MILITARY SPECIFICATION SHEET

BEARINGS, SLEEVE, FLANGED, SELF-LUBRICATING, 325°F

This amendment forms a part of MIL-B-81934/2C, dated 4 January 1988 and is approved for use by all Departments and Agencies of the Department of Defense.

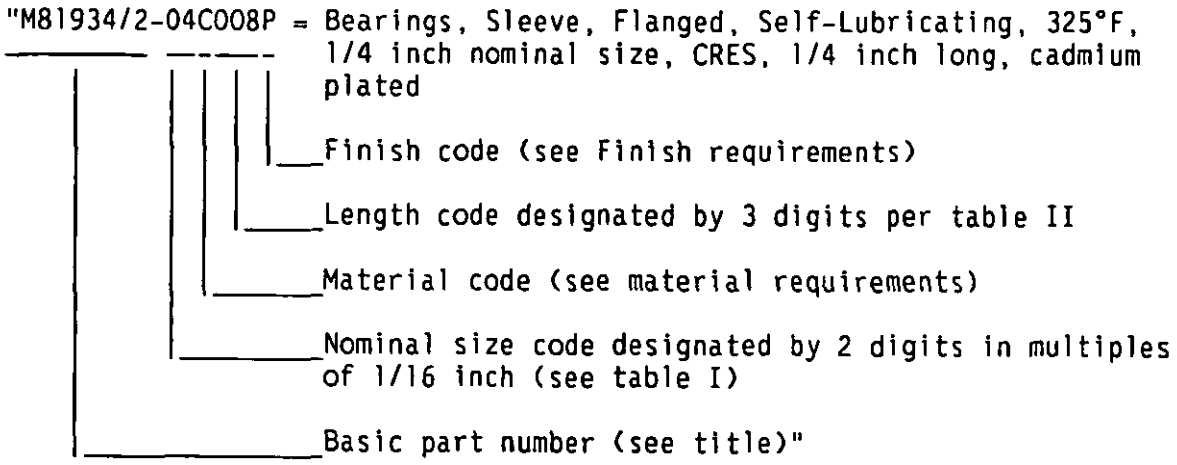
Under the heading "Example of part number," delete and substitute the following:
